AUBURN HILLS

Planning Commission
Wednesday, June 5, 2024 ❖ 7:00 p.m.

Subject: **The Learning Experience**
Public Hearing / Motion – Recommendation to City Council for Special Land Use Permit, Site Plan, and Tree Removal Permit approval

RE: The Learning Experience (TLE)
Site Plan 1st Review

DRAWING NUMBER:
C-8.0

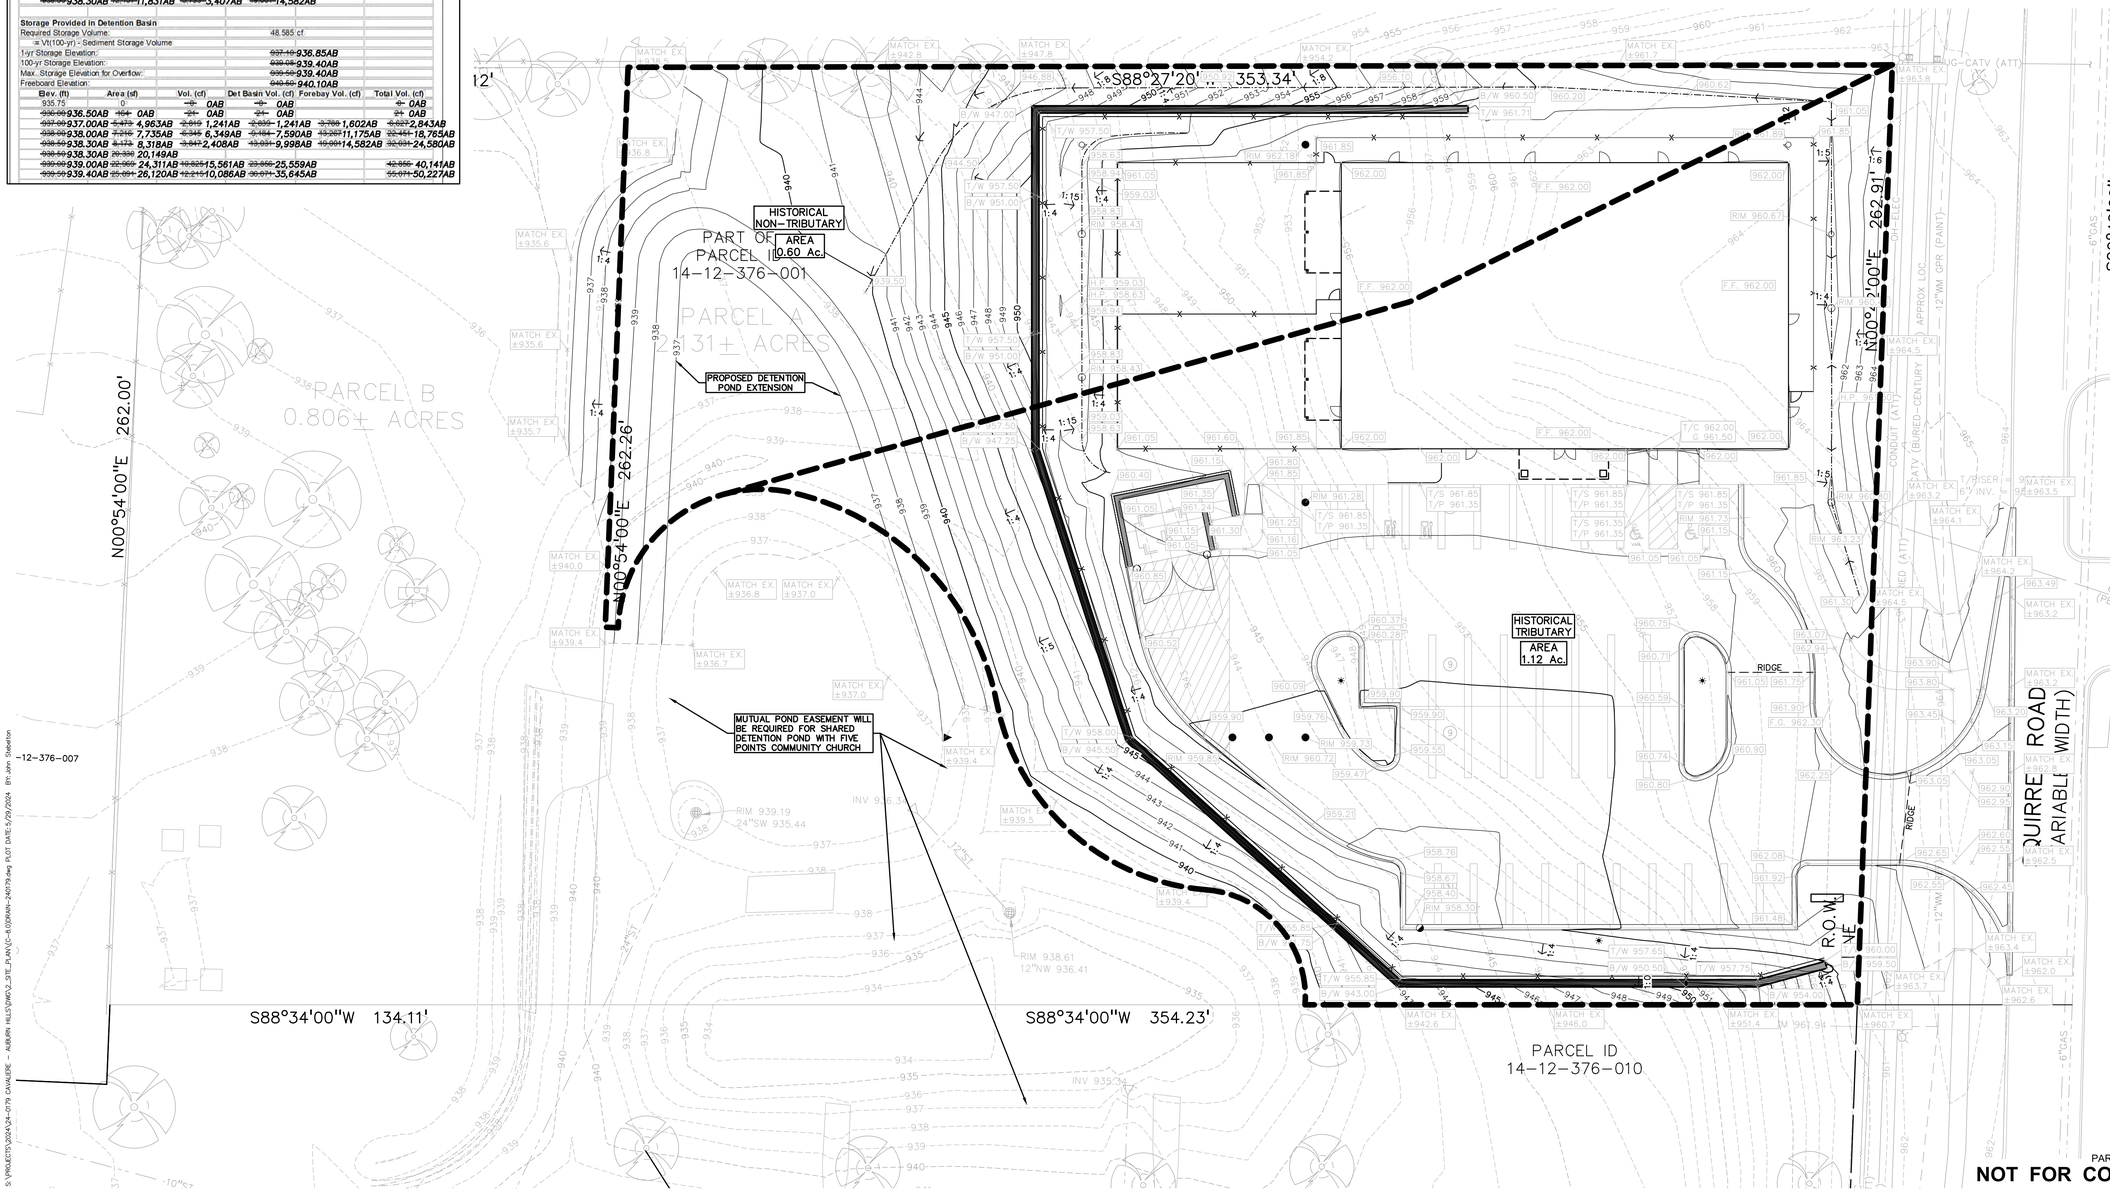
Multiple downspouts around the building will route storm water runoff to the proposed detention pond. A swale has been provided along the east, north, and west side of the site directing runoff to the detention basin. A cross-section meeting the County and City's pre-treatment standards for storm water shall be provided at engineering review. The following note has been provided on the plans, "Proposed swale shall meet the City and County's Best Management Practices and treatment standards." A water quality unit has also been provided on the plans prior to the storm water entering the detention basin. The water quality unit shall conform to City standards and additional details and calculations for the water quality unit will be needed for the engineering review. The existing detention pond and outlet control structure shall be restored to its original approved design condition. The pond shall be cleaned, volume verified, and the outlet control structure shall be in good condition or repaired as needed. Additional details of the stormwater management system will be needed for engineering review including storm sewer calculations, profiles, and hydraulic grade lines. The proposed slope of the storm sewer shall also be provided for engineering review.
